# PROPOSED WAREHOUSE DEVELOPMENT

**246 Miller Road, Villawood  
Riparian Management Advice**

SLR Ref: 630.30024-R01  
Version No: -v1.1  
June 2020

**Figure 1** Excerpt of Landscape Plan (showing tree removals on southern boundary)

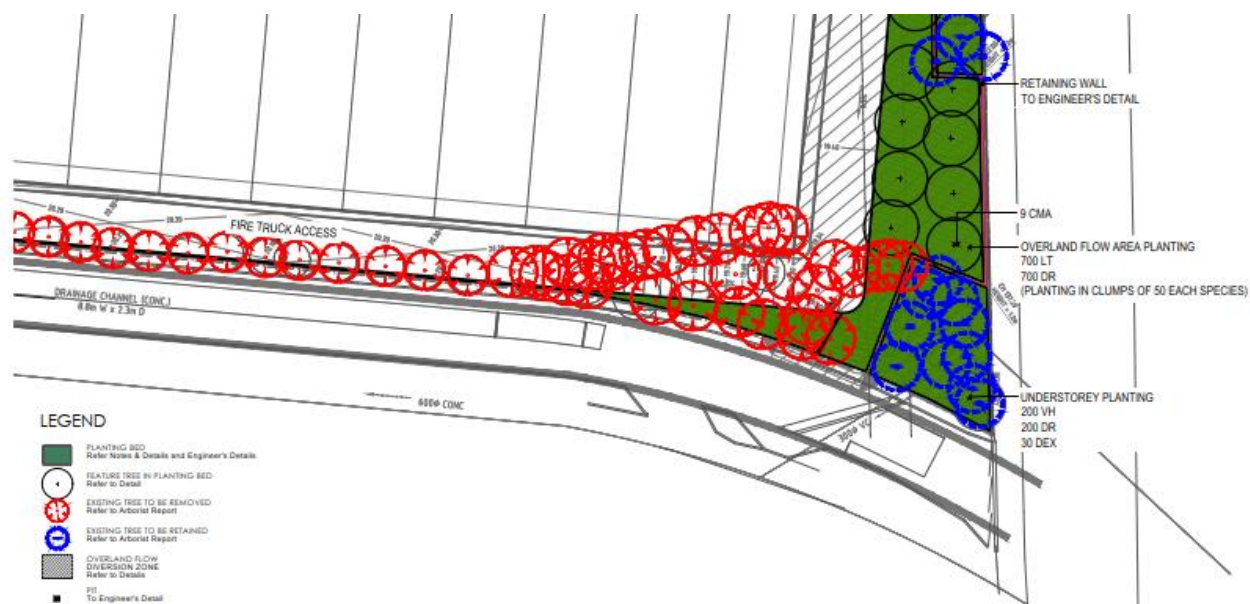
- A narrow belt of planted Black Tea-tree *Melaleuca bracteata*, which stretches along most of the southern boundary and occupies a width of approximately 0.5 m to 1 m (see **Photo 1**). These trees are identified for removal in the landscape plan (see **Figure 1**);
- a stand of planted Swamp Oak *Casuarina glauca* in the south eastern corner of the site, near the Miller Road entrance (see **Photo 2**). Most of these trees are identified for removal on the landscape plan (see **Figure 1**), with a small number of trees (including Spotted Gums) to be retained adjacent to Miller Road.

- Amend landscape plan to provide detailed drawing of proposed riparian planting area (i.e. vegetated riparian zone) along southern boundary;
- Create a 'vegetated riparian zone' between fire access road and channel bank, with imported clean substrate (sandy loam VENM soil or crushed sandstone) and plantings of local indigenous species; seek to maintain or rehabilitate the zone with fully structured native vegetation, in accordance with NRAR (2018) guidance;

CD-A-163 and CD-A-164

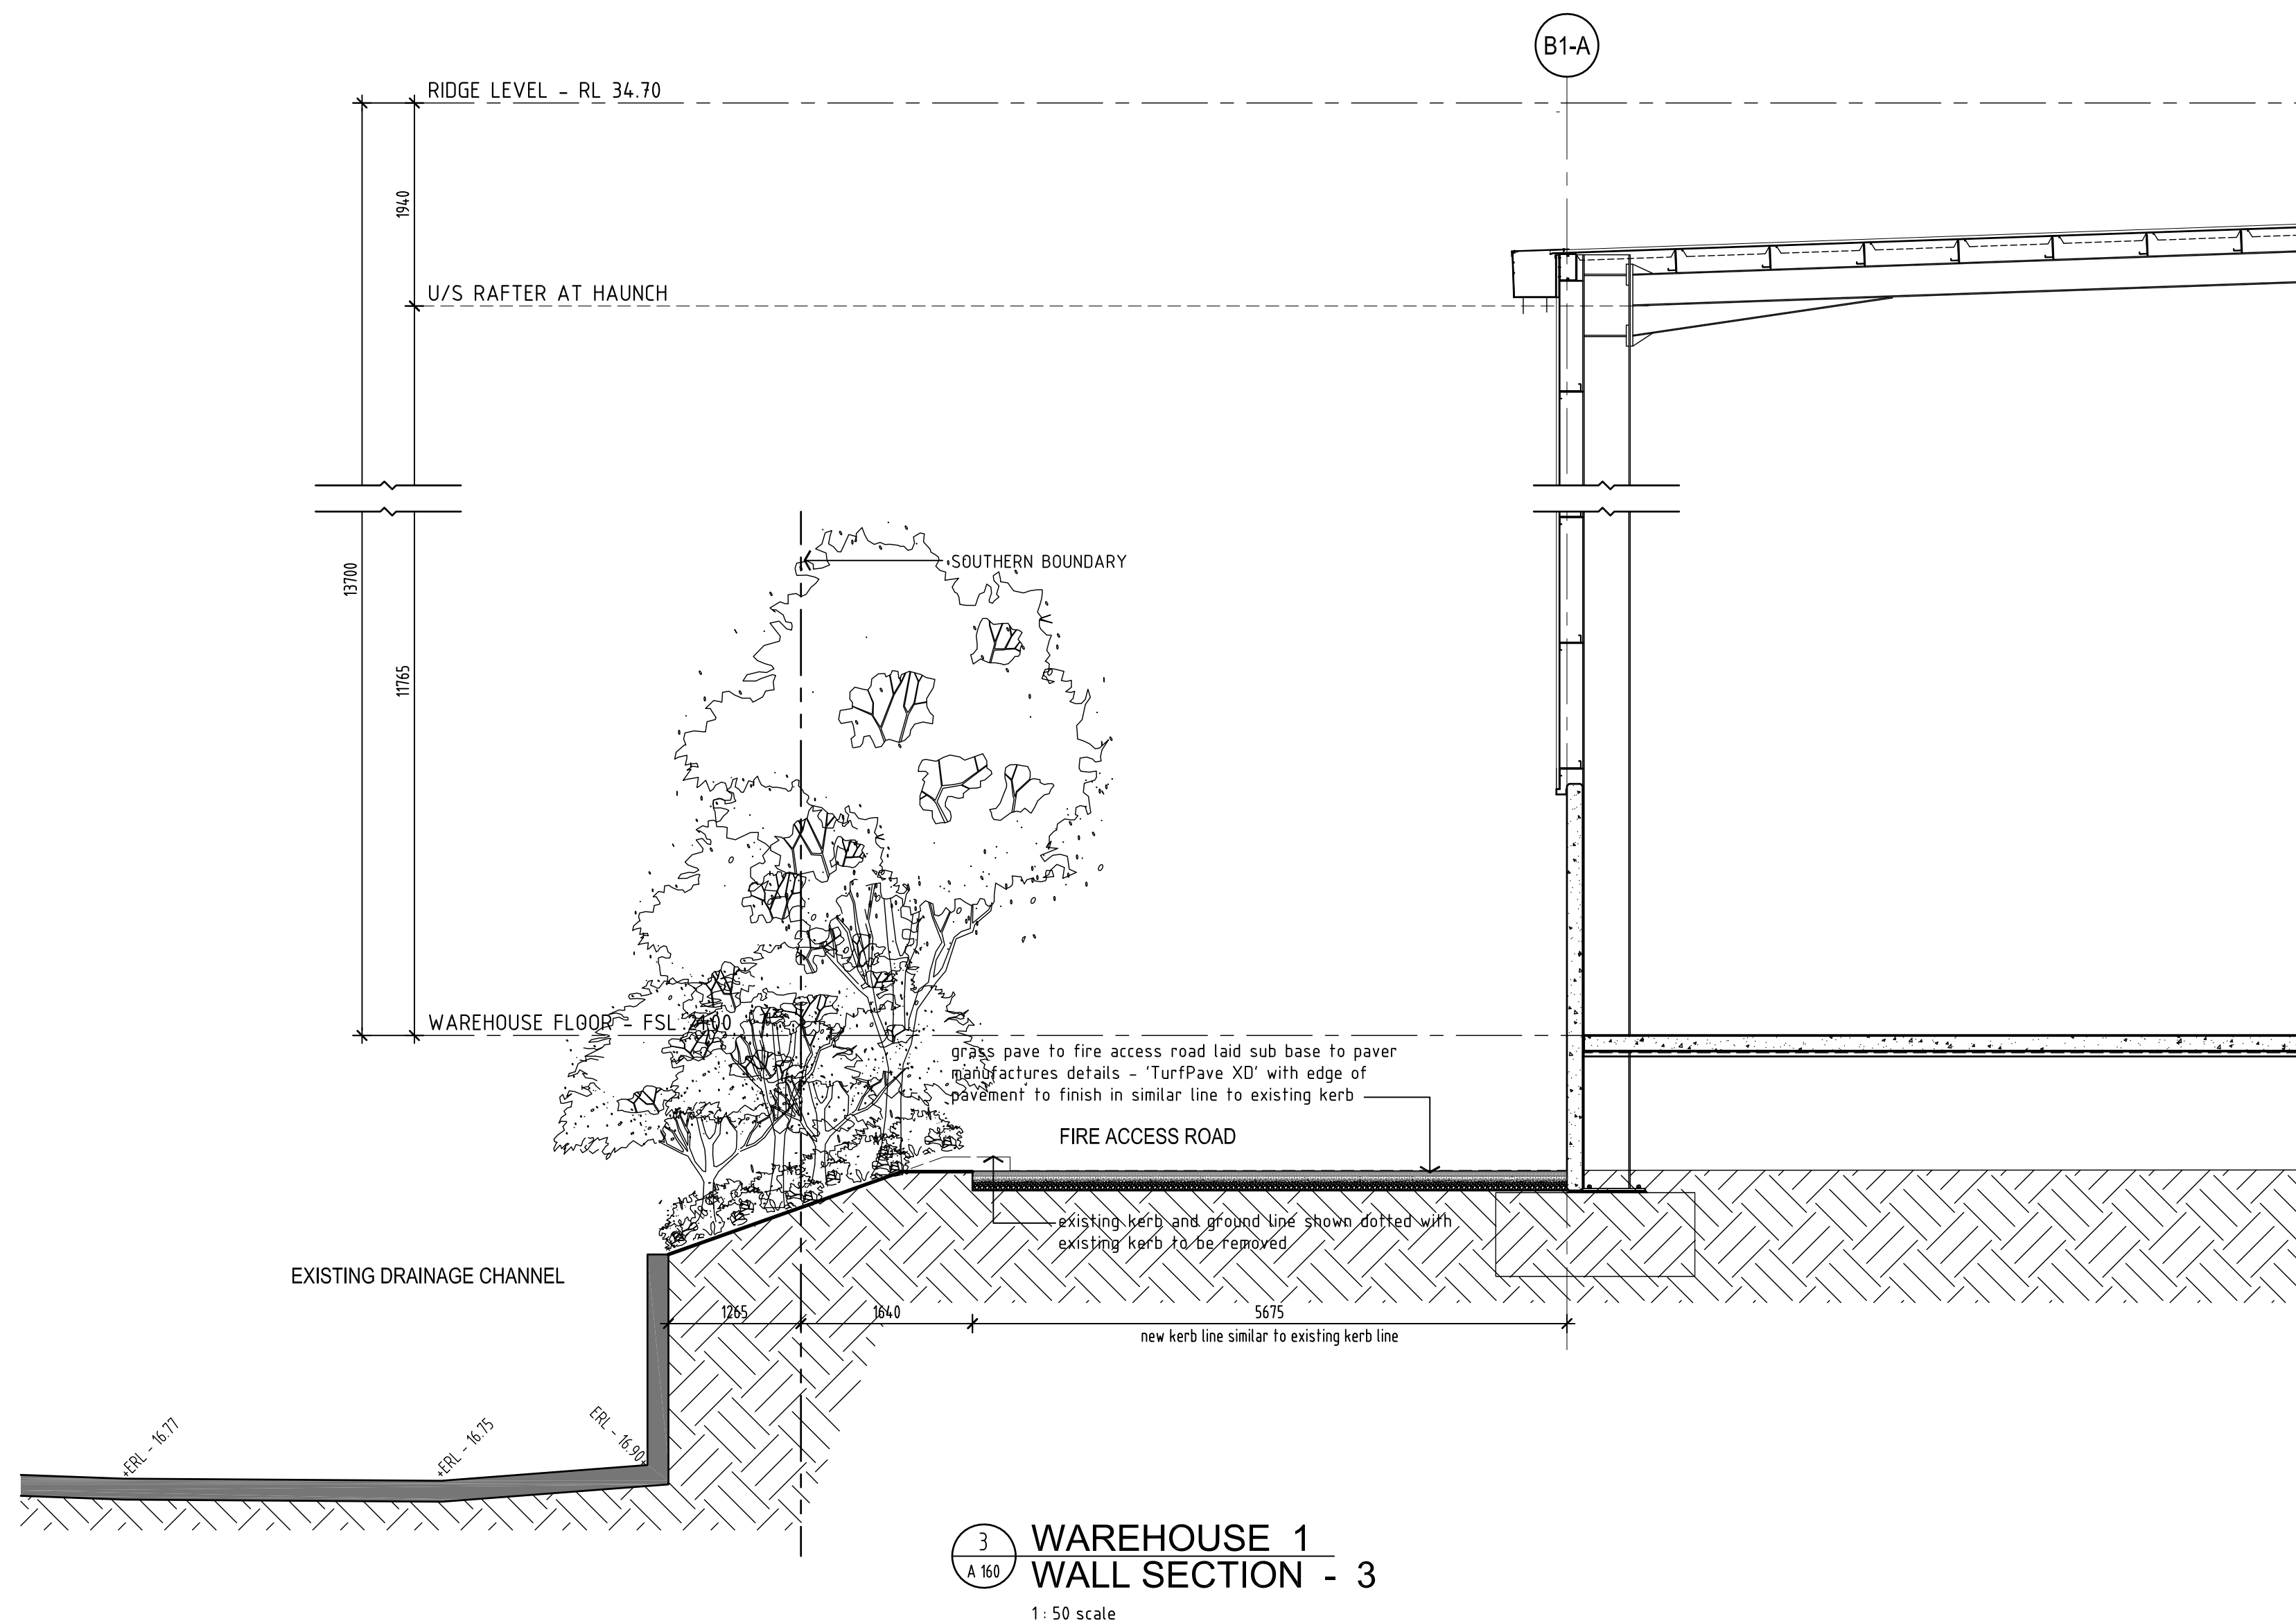
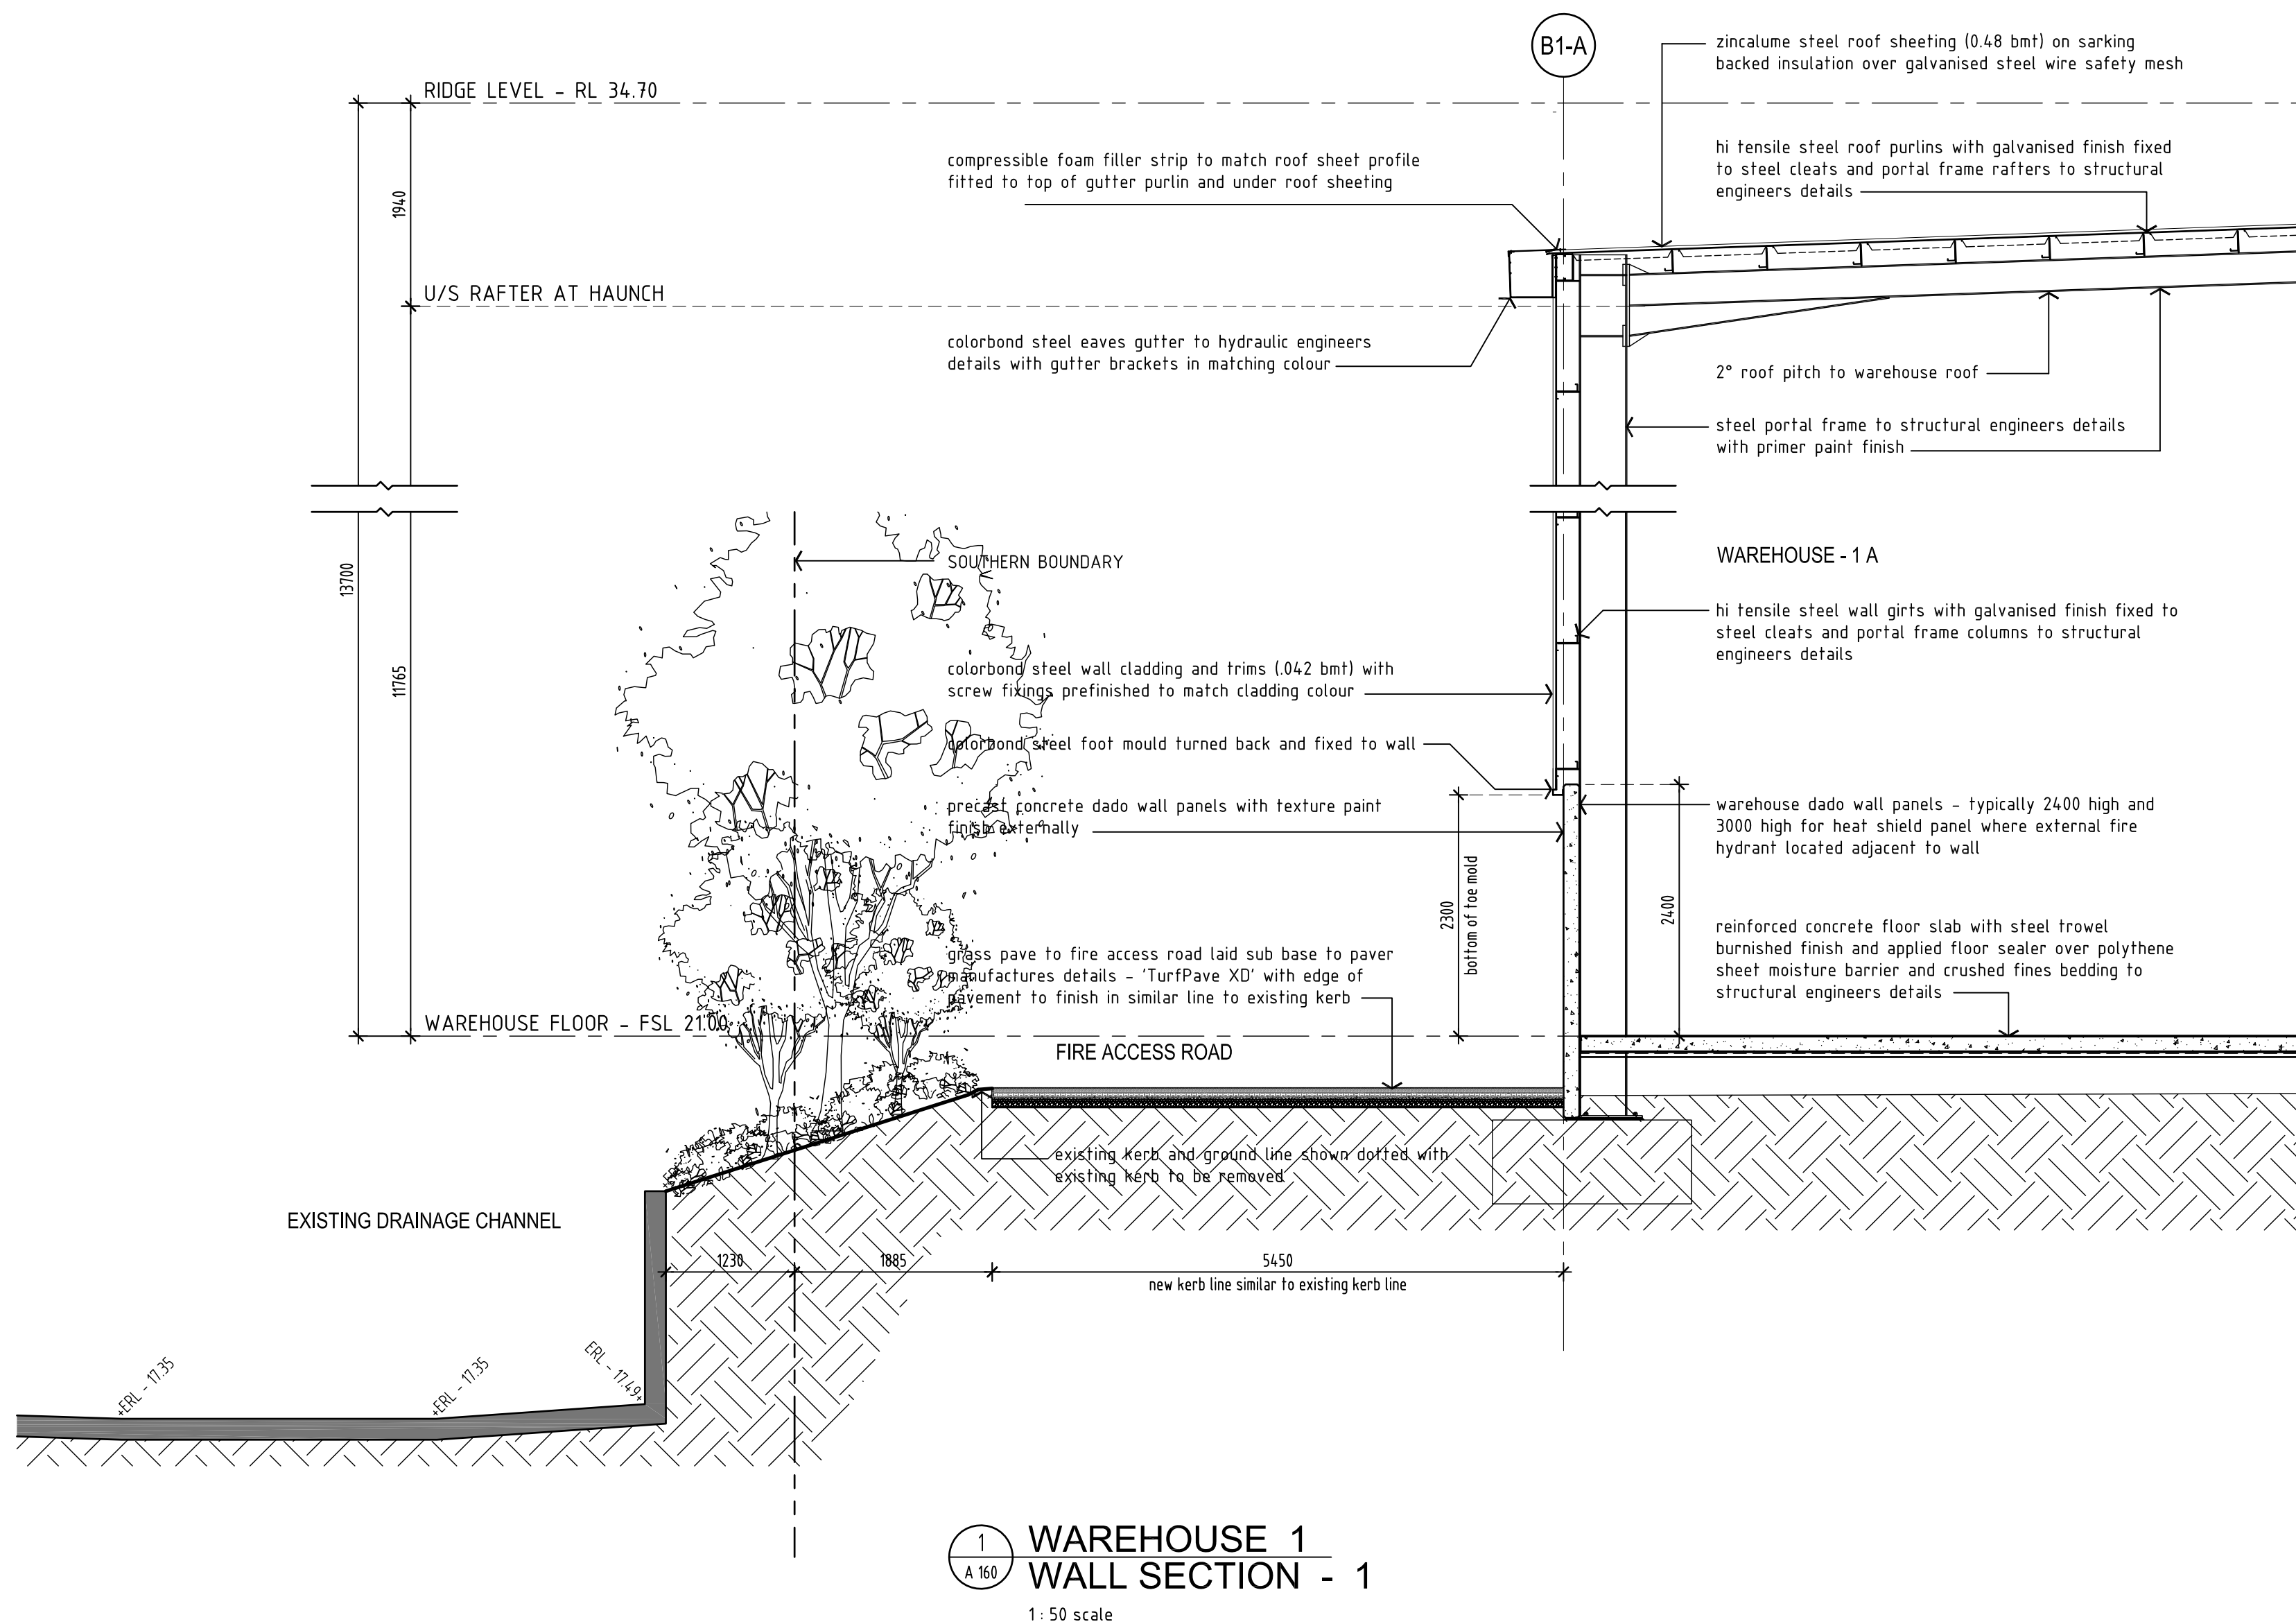
- Fire truck access road, which is a mandatory requirement to allow access for fire fighting vehicles. The amended proposal provides for a 5.675 m wide paved road, constructed of a permeable material (TurfPave XO).
- Vegetated Riparian Zone – between the fire access road, the southern site boundary and from the site boundary to the edge of the channel. This strip of land will be recontoured, with clean soil placed and planted with a selection of locally indigenous flowering plants (small trees, shrubs and groundcovers).

The total width of the proposed riparian zone extends from the top-of-bank of the channel to the edge of the proposed warehouse building with a total width of 8.6 m to 11.5 m (see **Appendix A**).

- Creates a vegetated riparian zone (or VRZ), consistent with NRAR guidance for waterfront land and with Clause 2.7 of the DCP, although it is acknowledged that the recommended width of the VRZ will not be 15 m as per the DCP or 10 m wide as per NRAR guidelines; the space limitations of the site and the design requirements of the proposed warehouse, as well as the requirements for a fire access road, do not allow a riparian corridor of greater width;
